ASAHI YUKIZAI CORPORATION Valve & Piping Systems Division

Electric Z Type Defect Notice

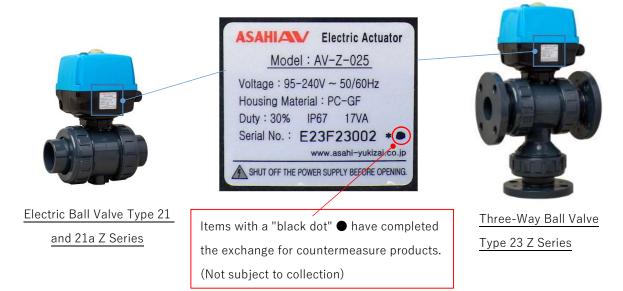
- 1) Product Names:
- i) Electric Ball Valve Type 21 and 21a Z Series
- ii) Three-Way Ball Valve Type 23 Z Series
- Specifications:
- All size (15-50mm), all body materials, all seal materials
- 2) Scope of Affected Products: i) Products Shipment Period: From July 2021 to July 2024
 - ii) Actuator Serial No.: E21E10001 to E24D08020

(those with black dots are excluded)

We will replace the drive units of the affected products that you are using or storing with modified units. For the affected products currently in use, we will confirm the usage conditions and discuss the timing of the replacement and the details of the replacement work, and we will implement the response promptly.
